## ORIGINATION FORM

Proposed Revisions to a Standard Plans Index  
(Please provide all information — Incomplete forms will be returned)

Index Number: 711-003  
Sheet Number (s): 5 and 6  
Index Title: Interchange Markings

Index Number: 711-003  
Sheet Number (s): 1, 2, and 5  
Index Title: Interchange Markings

**SINGLE LANE RAMPS - ENTRANCE TERMINALS**

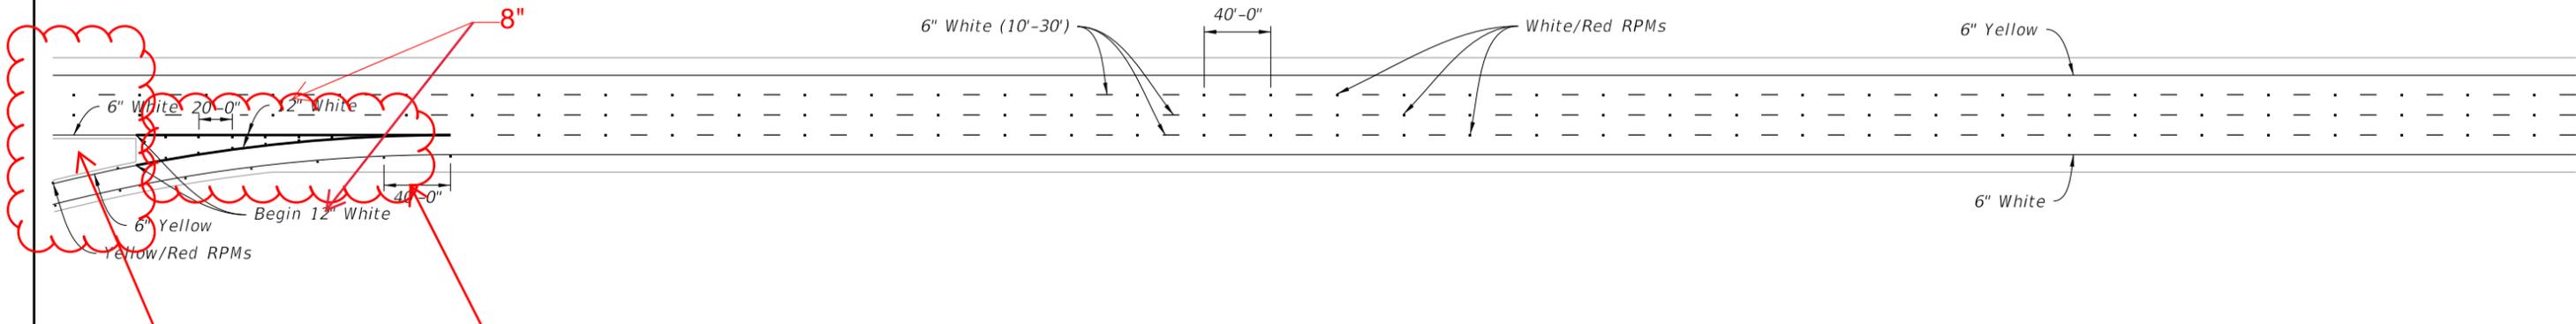
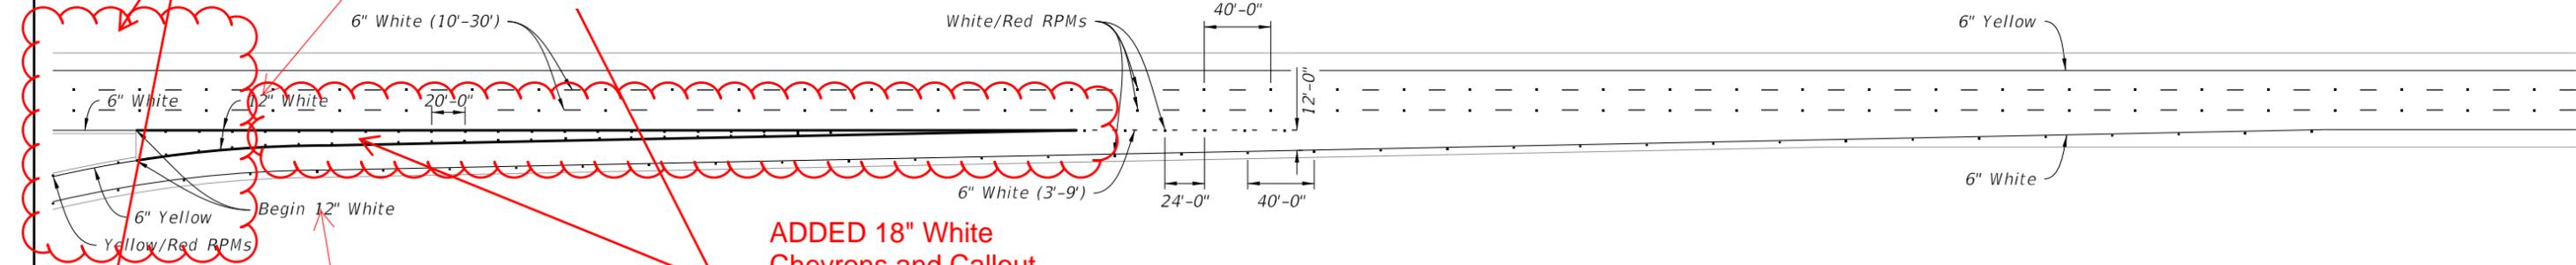
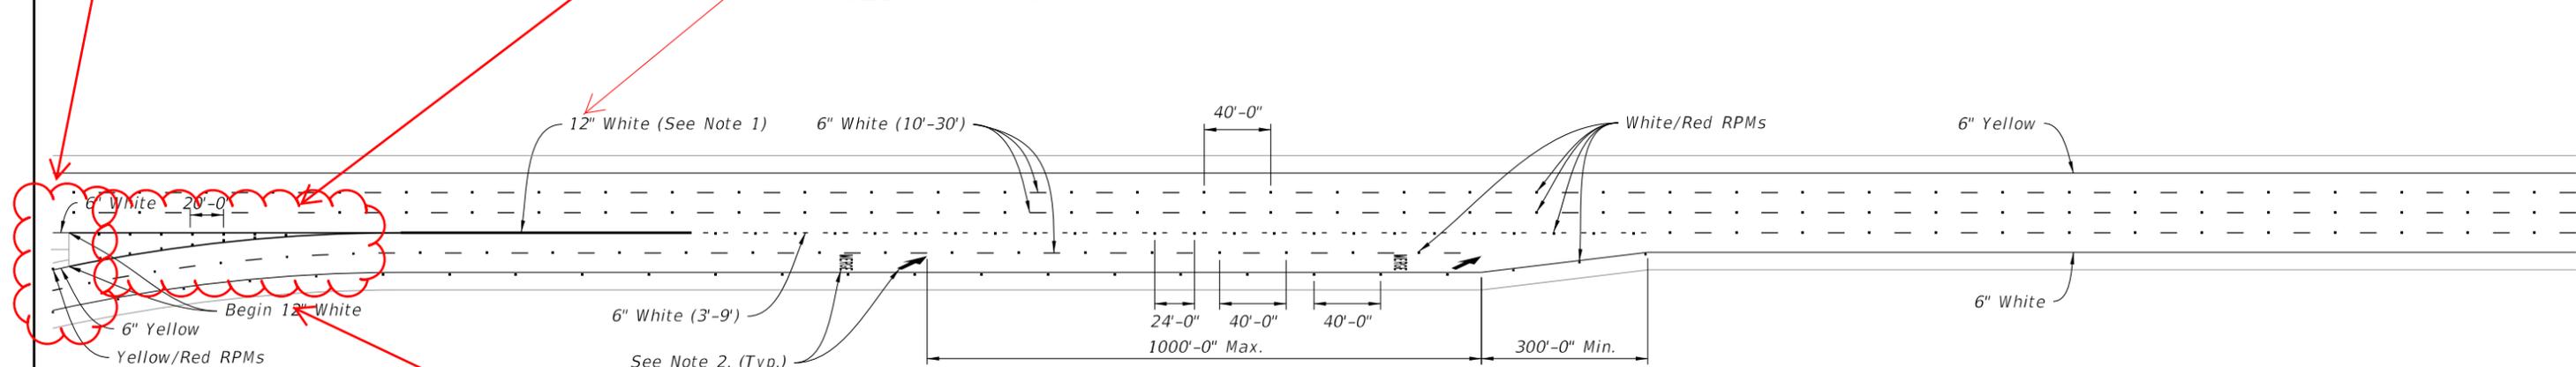
Sheet 1: Add 18" white Chevrons to both entrance ramps. Dotted line for lane extension to extend to end of taper.  
Sheet 2: Add 18" white Chevrons to both entrance ramps. Dotted line for lane extension to extend to end of taper.  
Sheet 5: Add 18" white Chevrons to entrance ramp gore.

ADDED 18" White Diagonal line and Callout to See DETAIL "B" on Sheet 3

CHANGED TO: 8" White

ADDED 18" White Chevrons and Callout to See DETAIL "A" on Sheet 3

CHANGED TO: 8" White

CHANGED TO: 8" White

CHANGED TO: 8" White

**TYPICAL PAVEMENT MARKINGS AT ENTRANCE RAMPS**

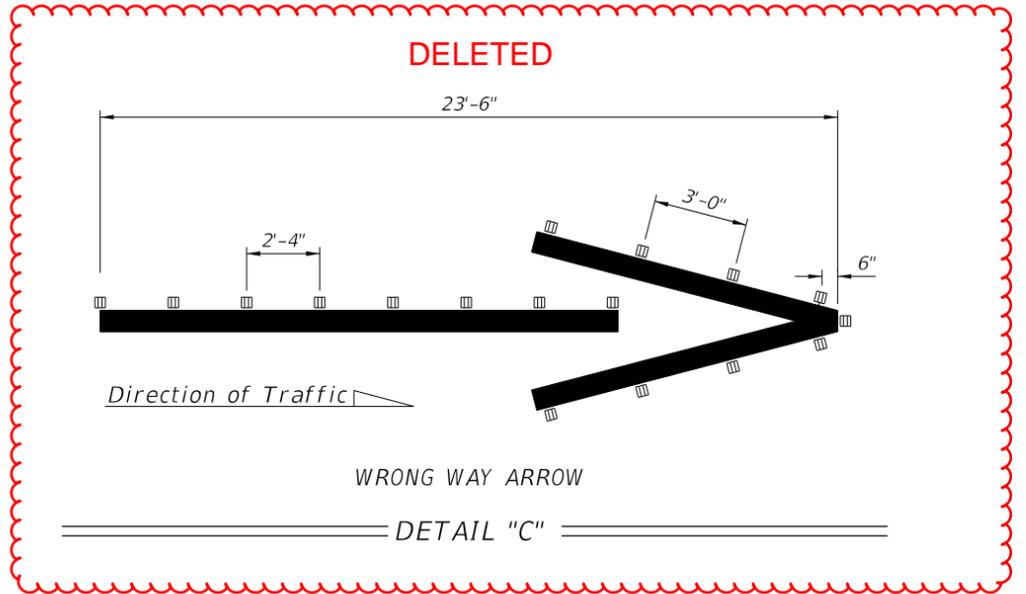
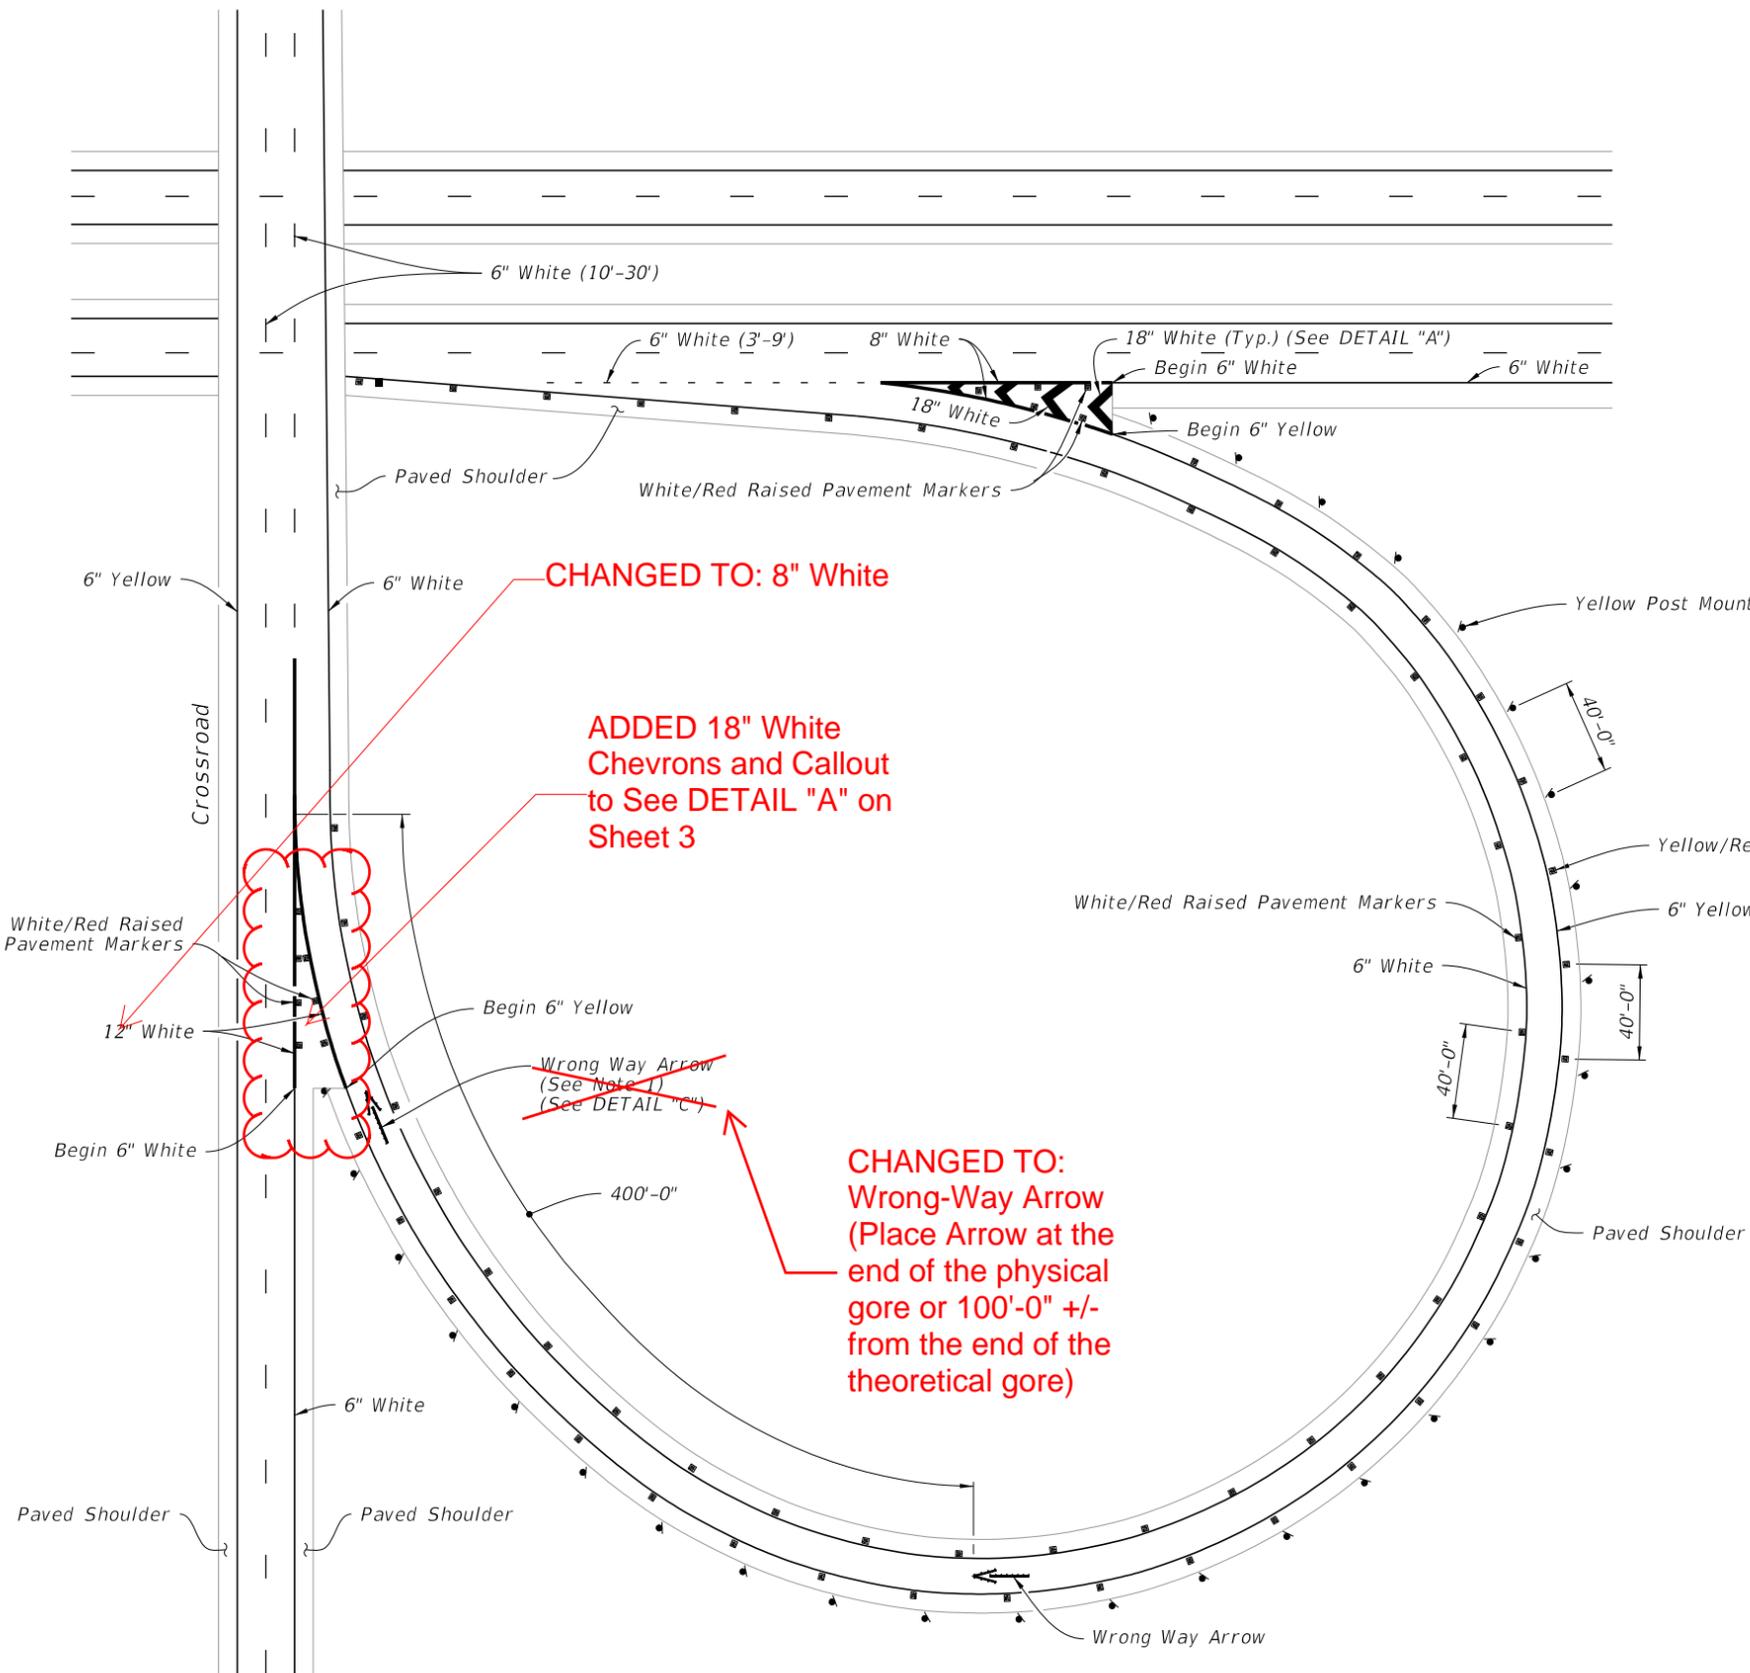
**CHANGED TO: 8" White**

**ADDED 18" White Chevrons and Callout to See DETAIL "A" on Sheet 3**

**TYPICAL CURVED EXIT RAMP AND WRONG WAY ARROW**

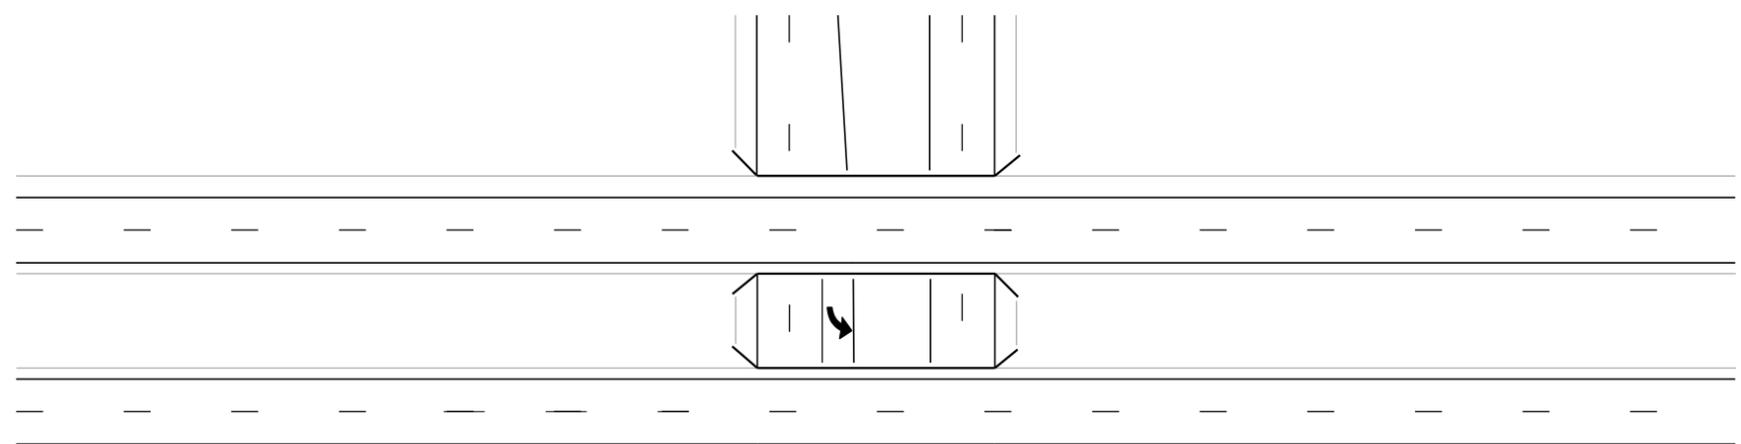
Sheet 5: Moved Detail "C" from sheet 5 to Sheet 3 of Index 706-001; Moved Note 1 to the Wrong-Way Arrow callout at the Gore; Deleted Note 2; Deleted the "See Note 3" reference from the Yellow Post Mounted Delineator callout.

**CHANGED TO: Wrong-Way Arrow (Place Arrow at the end of the physical gore or 100'-0" +/- from the end of the theoretical gore)**

- ~~1. Place the Wrong Way Arrow at the gore.~~
- 2. Post delineators spaced at 40' on curves of the entrance and exit of ramps. The spacing on the tangent portion of the ramp section is 300'-0". All delineators are to be setback 4' from shoulder break. Post delineators should not be discontinued in sections with guardrail.

**Deleted from title**

**TYPICAL INTERSECTION**

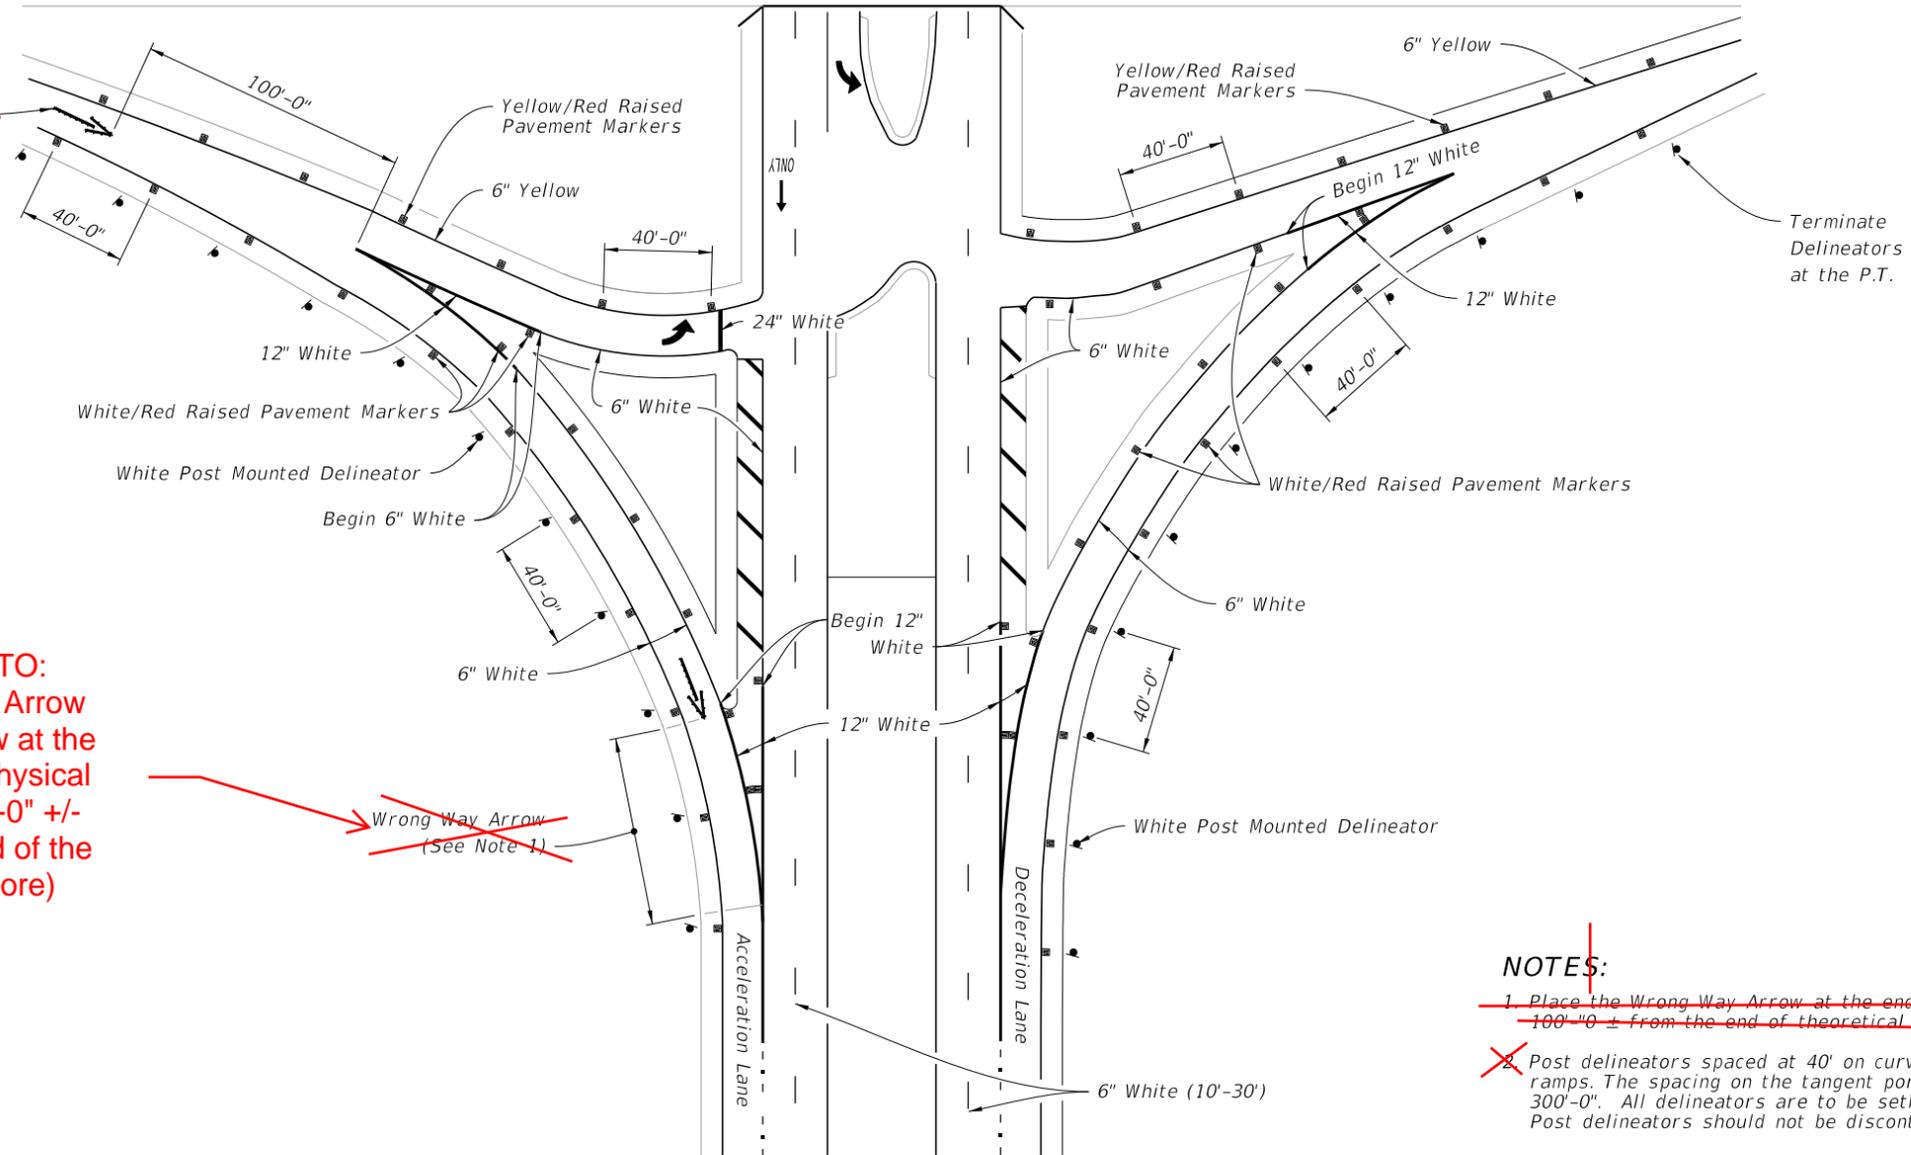
Sheet 6: Moved Note 1 to the Wrong-Way Arrow callout at the Gore; Deleted the note reference and the Detail "C" reference for the Wrong-Way Arrow callout on the off ramp.

~~Wrong-Way Arrow (See Note 1)  
(See DETAIL "C", Sheet 5)~~

**CHANGED TO:**  
Wrong-Way Arrow  
(Place Arrow at the end of the physical gore or 100'-0" +/- from the end of the theoretical gore)

- ~~1. Place the Wrong Way Arrow at the end of the physical gore or 100'-0" +/- from the end of theoretical gore.~~
- ~~2. Post delineators spaced at 40' on curves of the entrance and exit of ramps. The spacing on the tangent portion of the ramp section is 300'-0". All delineators are to be setback 4' from shoulder break. Post delineators should not be discontinued in sections with guardrail.~~
